**Historic Landmarks Committee  
ZOOM Online Meeting  
May 28, 2020 3:00 PM**

**DATE:** May 28, 2020  
**TO:** Historic Landmark Committee Members  
**FROM:** Chuck Darnell, Senior Planner  
**SUBJECT:** Request for Change in Materials - HL 3-19 (Certificate of Approval for New Construction) & DDR 2-19 (Downtown Design Review)  
618 NE 3<sup>rd</sup> Street – Taylor Dale 2 Building

**Design Review Narrative for using a Previously Approved Exterior Finish Alternative**  
**Property at 618 NE 3<sup>rd</sup> Street, McMinnville, (Project Name: TD-2)**  
**Previously approved narratives are attached and have been modified on for this application.**

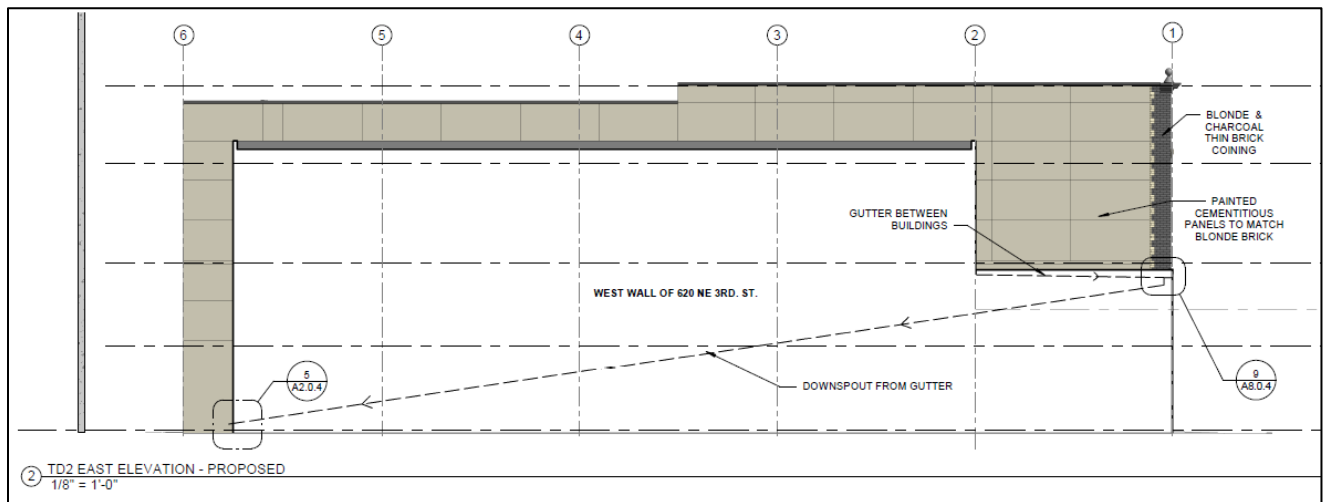
The applicant is now requesting a change in some of the exterior materials on the new building. The specific changes requested are described by the applicant as follows:

The applicant does note in their narrative that their original application submittals (HL 3-19 and DDR 2-19) did include a statement in the description of the project that "The exposed portions of the east façade

EXTERIOR  
ELEVATIONS -  
PROPOSED

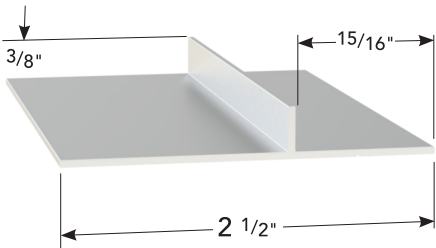
The comparative unit costs for the finishes in question are: **Stucco:** \$32/sf; **Thin brick:** \$30/sf; **Hardie Panel** \$7/sf, **Hardie Shiplap** siding \$9/sf.
